Dhaka Garments & Washing Ltd

Dakkhin Vangnahati, Sreepur, Gazipur-1740
(24.192597, 90.457385)

30th December 2019 & 3rd February 2020

Observations

Beam layout plan

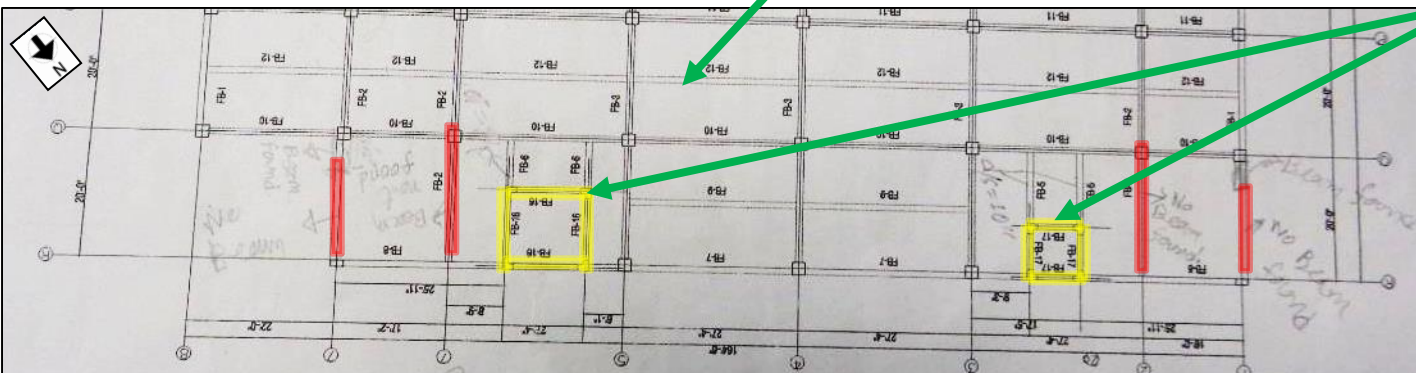
Details of the beam FB-16 & 17 (yellow marked) has not been shown in drawing.

Beam was not found at factory site (Red marked). But in as-built drawing, beam has been shown in drawing.

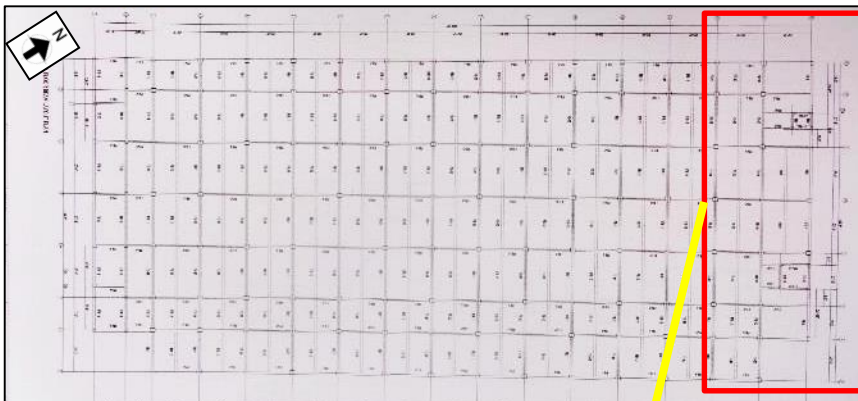
Beam was not found at site condition but shown in as-built drawing

Beam layout plan

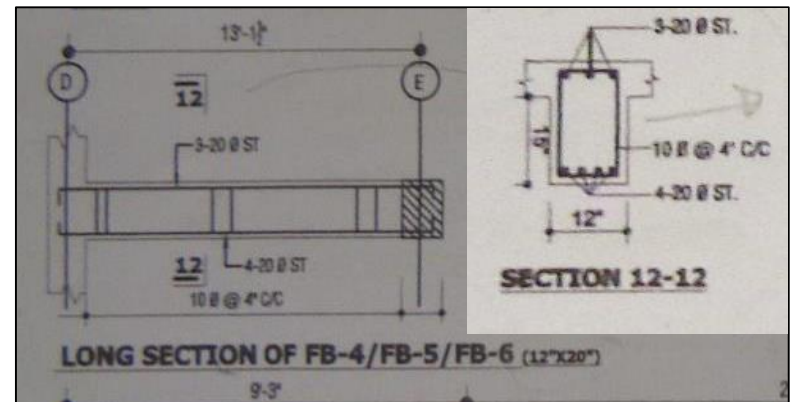
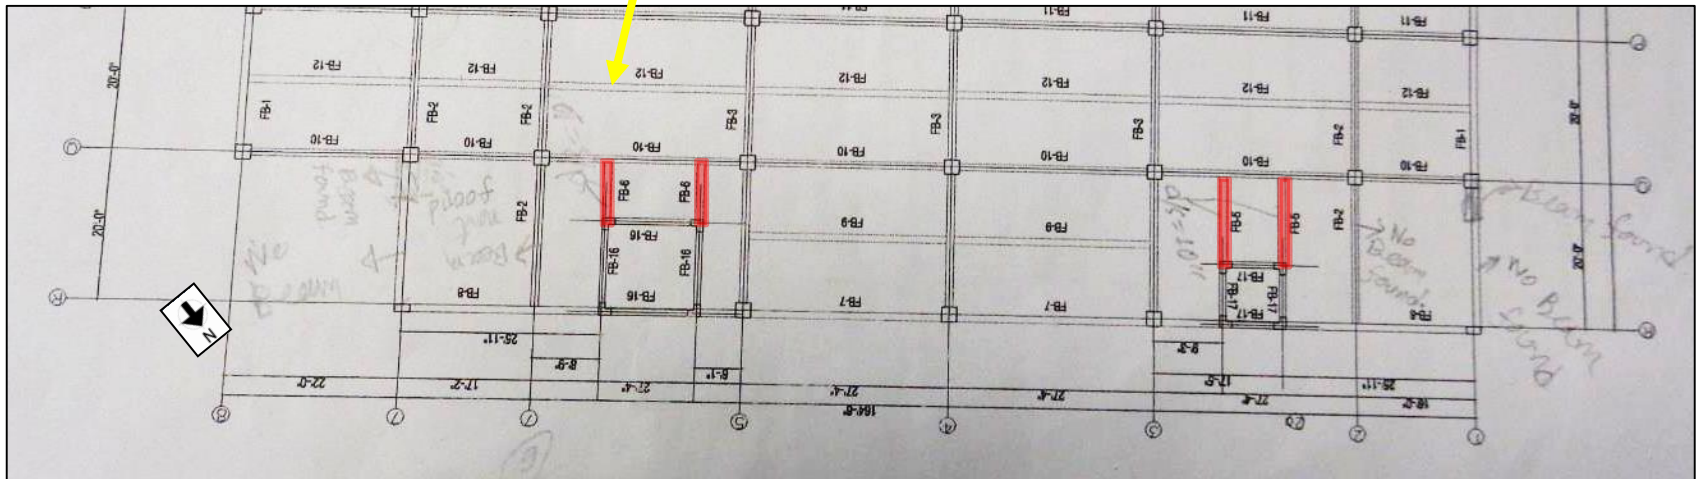
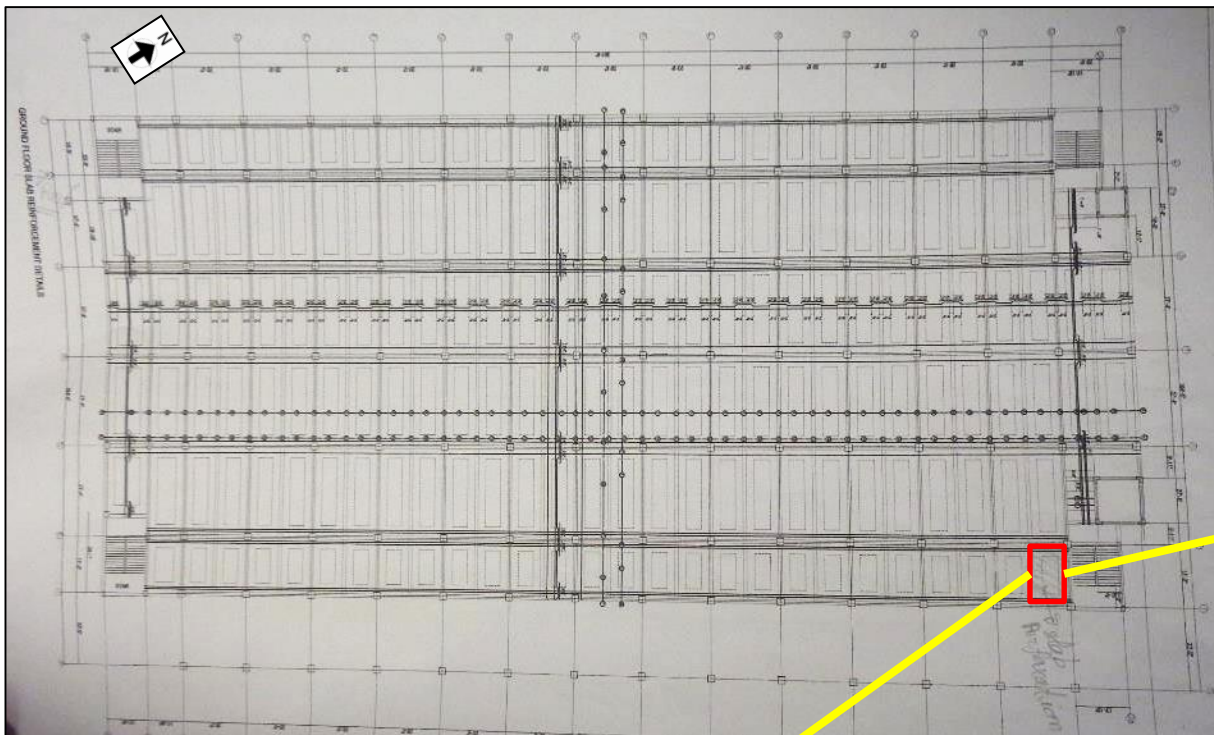
D/S depth has been shown 375mm

D/S depth was found 250 mm

In as built, drawing the D/S depth of FB-5 & FB-6 has been shown 375mm. But at factory site, the D/S depth of the Beam was found 250mm.

Dampness in bottom slab of water tank

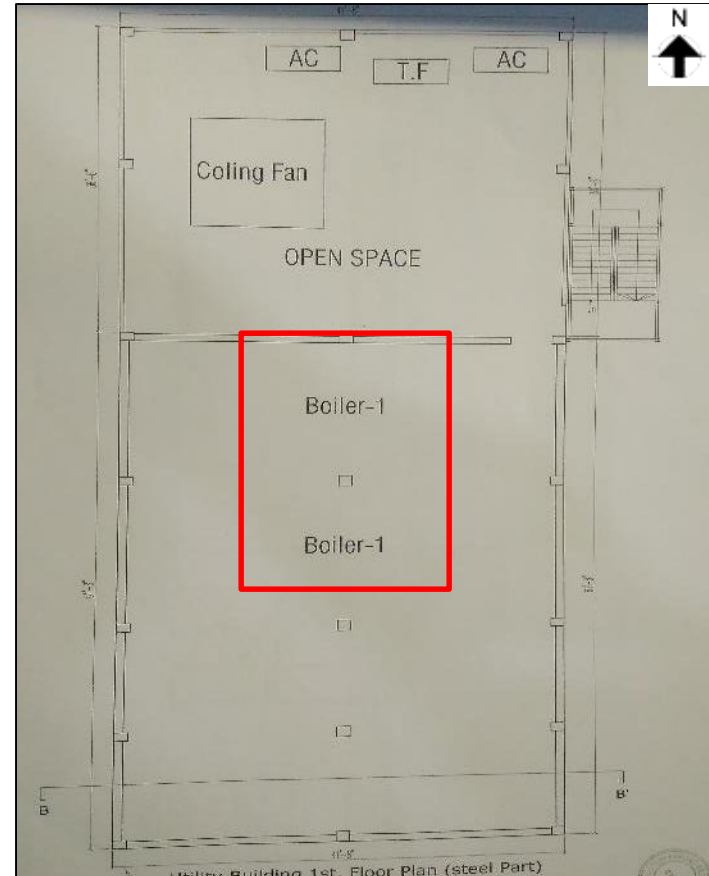
Dampness was found in bottom slab of overhead RC water tank (Northern side). Factory engineer is required to investigate the reason for the seepage of moisture and suggest remedial action.

Column appeared to be slender

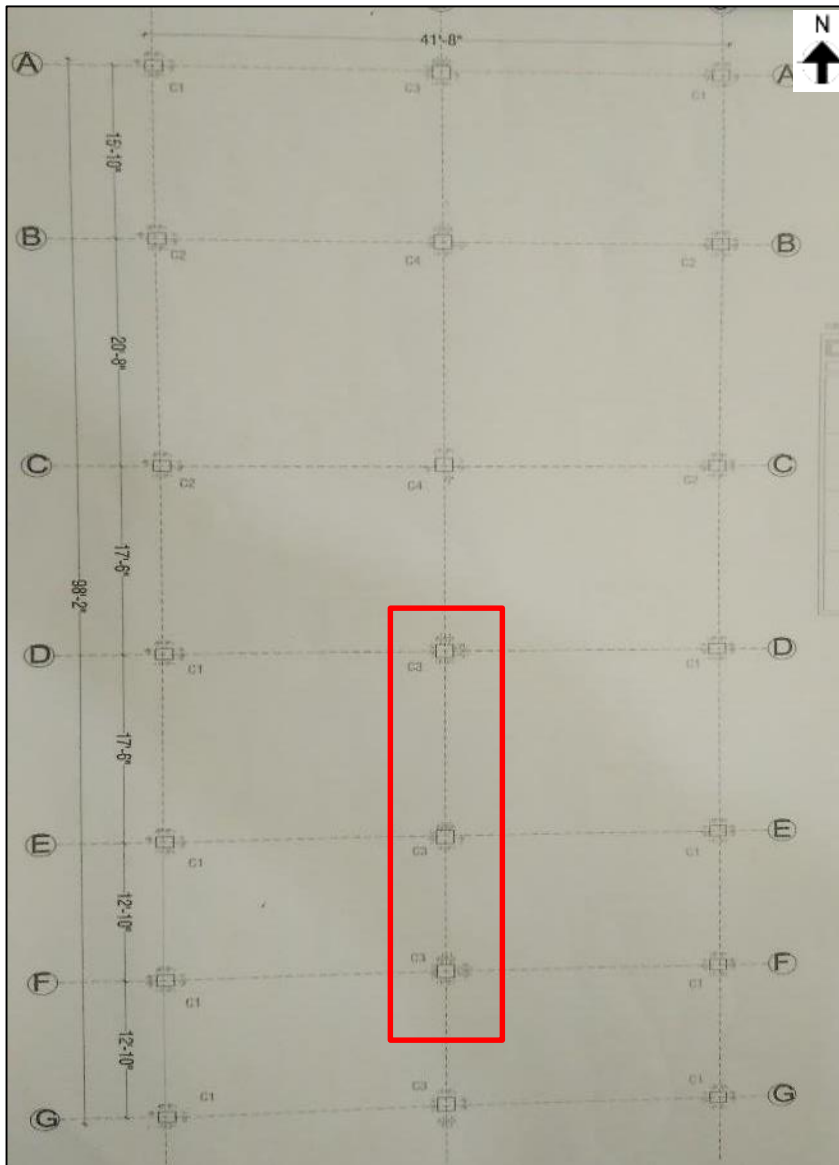
6.2m
Unsupported
height

Column appeared to be slender with long
unsupported length

Factory engineer is required to carry out
the adequacy check of the columns and
implement remediation if required.

Discrepancy in as-built drawing & lack of as-built drawing in RMS Guard Room

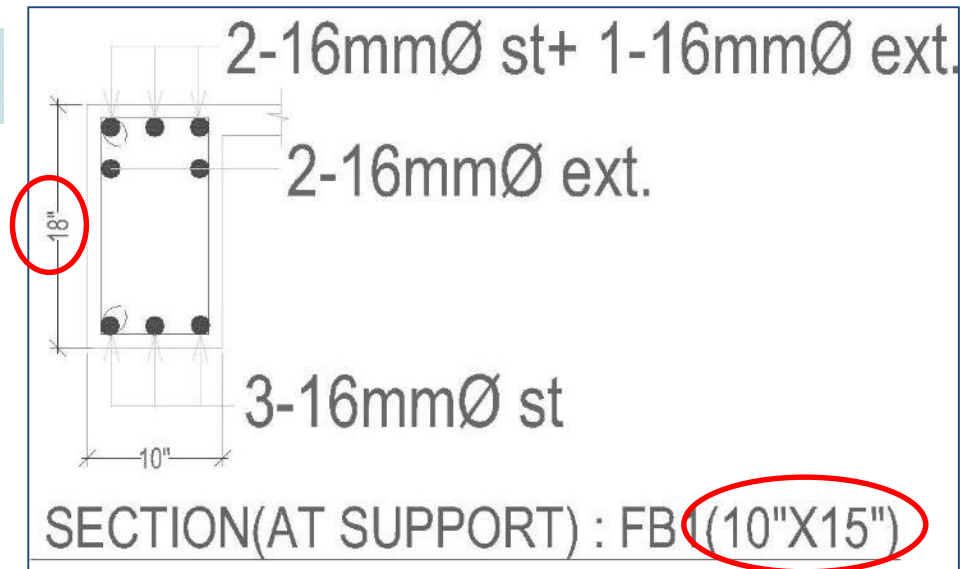
In sectional drawing, the dimension of RCC beam is written 18 inch but in site the dimension was found 15 inch

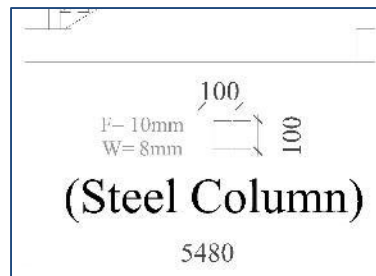
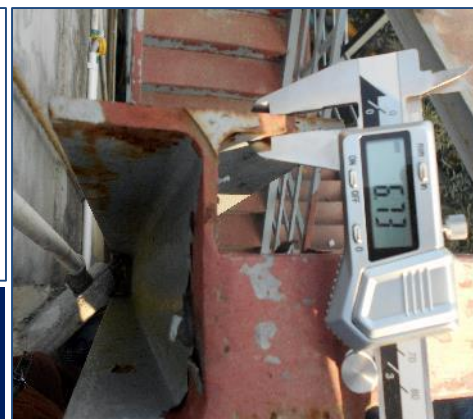
Thickness of web section
5 mm

Thickness in
drawing F10 mm
W8mm

Thickness of flange
section 6mm

Discrepancy was found between as-built drawing. The dimension of web of I column was found to be 100 mm instead of 130 mm. the thickness was also found lesser than mentioned.

Lack of fixity in support of steel stair

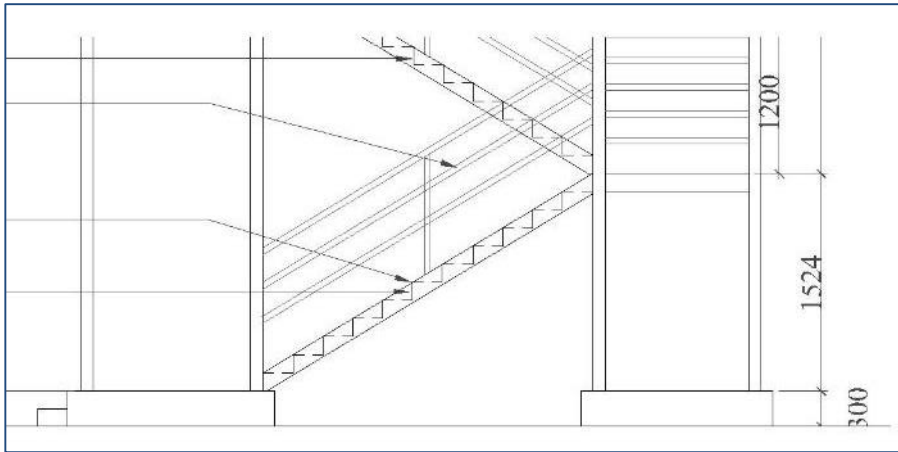
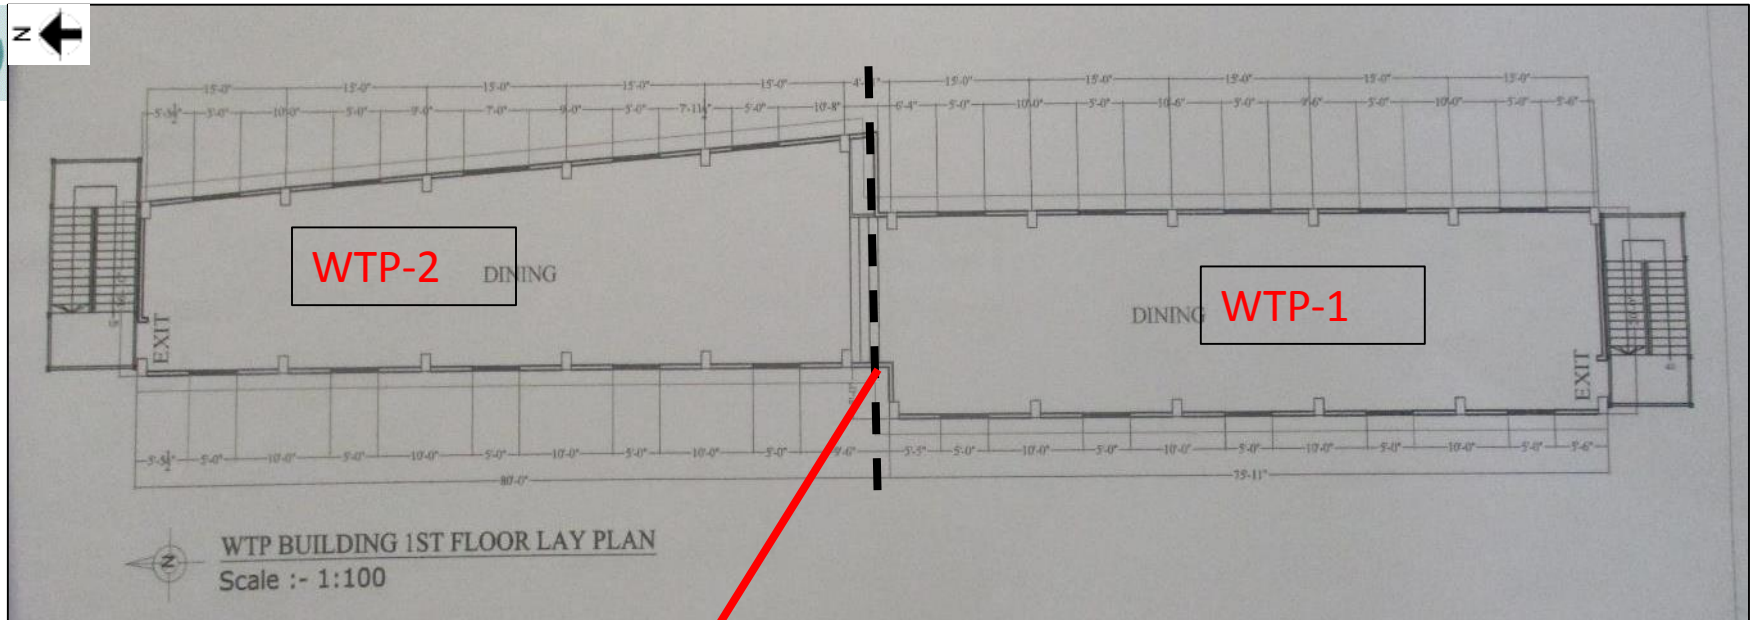
Stair column on self support

No fixity (pin or fix) between baseplate and short column was observed.

No fixity (pin or fix) between baseplate and short column was observed.

Lack of lateral stability

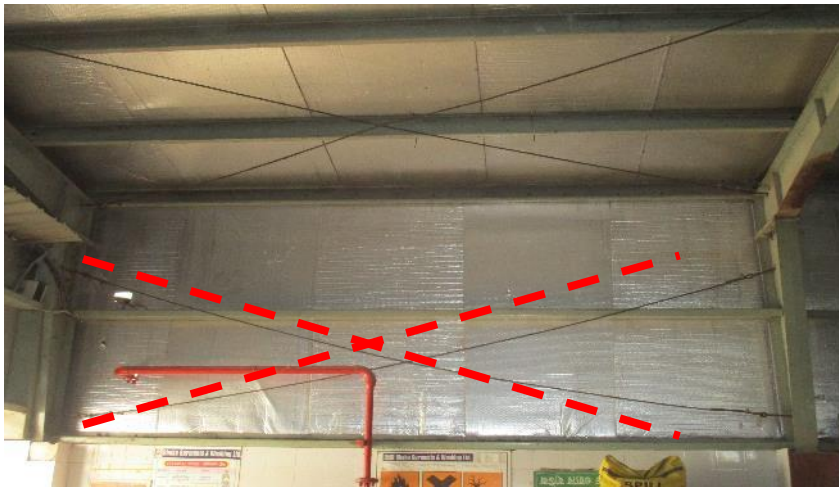
No eave beam/compression strut along long direction

Vertical bracing provided at half height only

Only tension bracing provided for long and short direction for lateral stability. No compression member provided in long direction. Building engineer is required to check the lateral stability system of the shed.

Discrepancy between as-built drawing & as-built condition

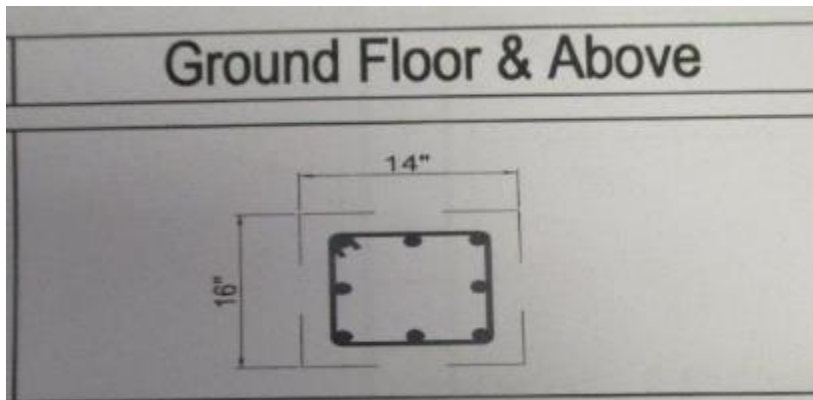
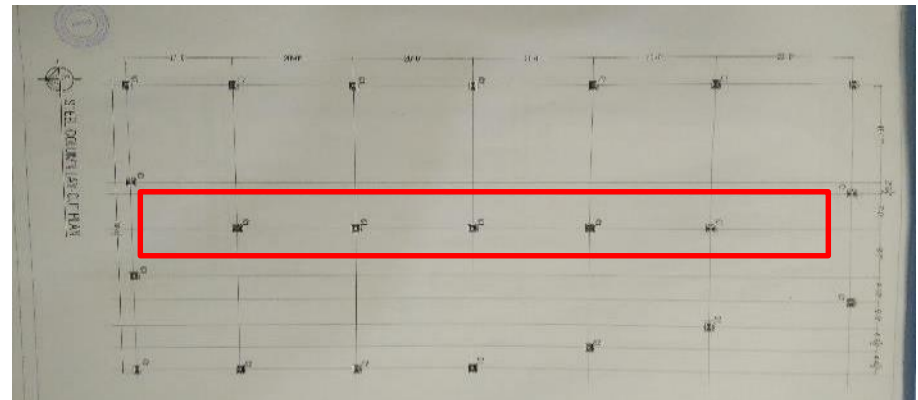
Dimension of pedestal column was measured as 350mmX 300mm without render instead of 400mmX350mm. Also orientation of all internal columns were found 90 degree rotated from original position

Dimension of all column shown as 400mmX350mm

All internal pedestal column found 90 degree rotated

Factory engineer is required to carry out the adequacy considering the changes and update as-built drawing

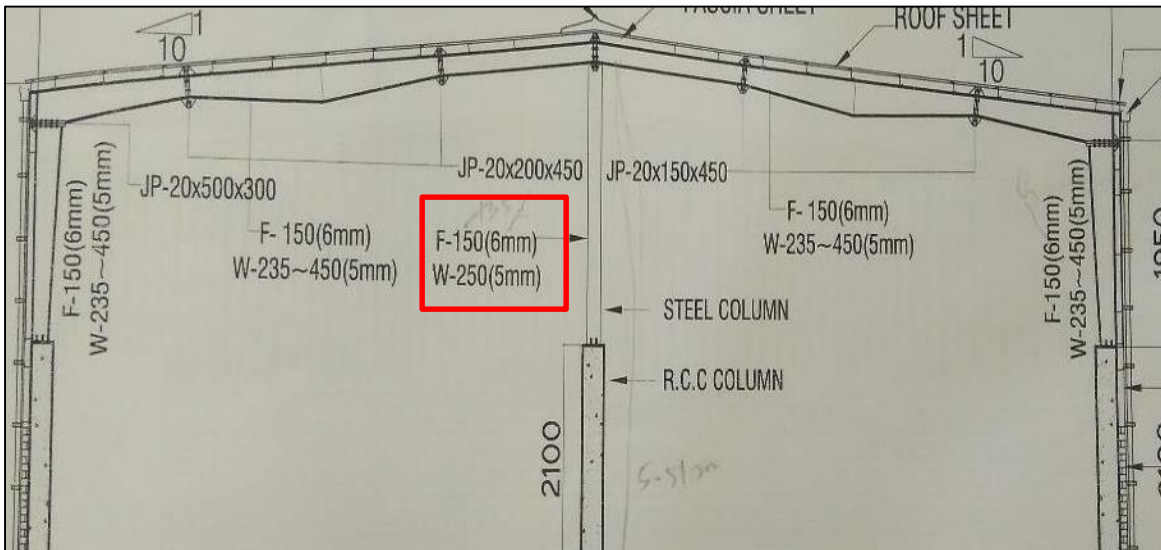
Flange dimension and thickness of all internal steel columns were measured as 135mmX5mm instead of 150mmX6mm

Dimension of flange shown in drawing as 150mmX6mm

Factory engineer is required to update as-built drawing and carry out the adequacy of the shed considering the changes.

Loose bracing & connection gap

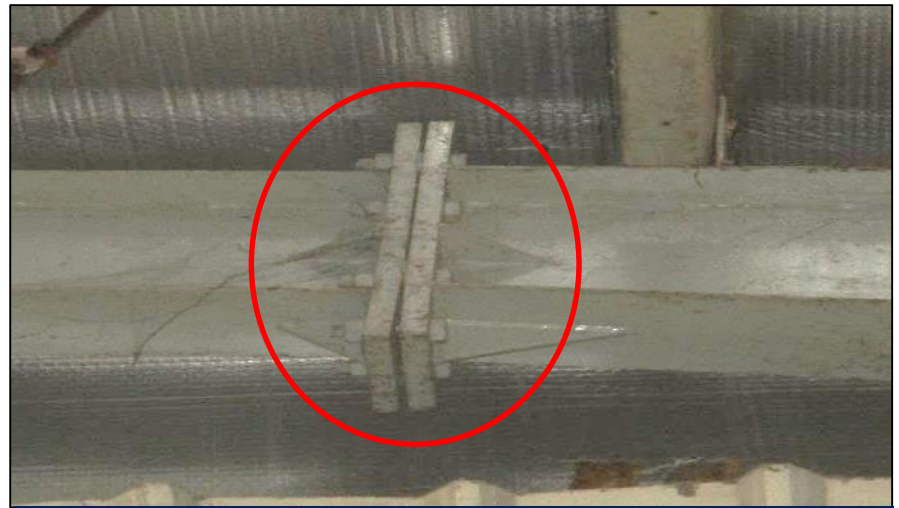
Gap in rafter to rafter connection

Gap in rafter to rafter connection

Loose vertical & roof bracing

Loose bracing and connection gap were found at several locations. Factory is required to tighten the loose bracing & repair the gaps with a suitable method suggested by the factory engineer.

Missing bolts in structural members

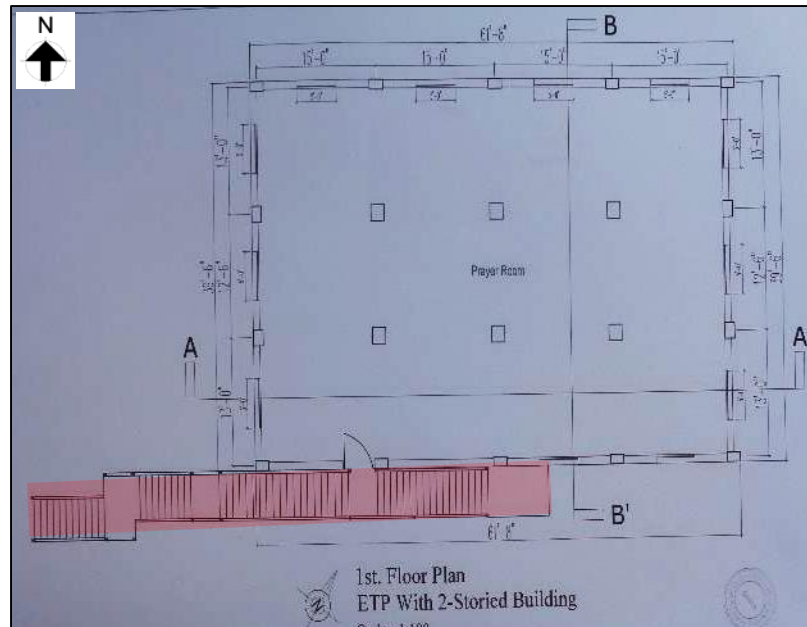
Bolts were missing at several locations
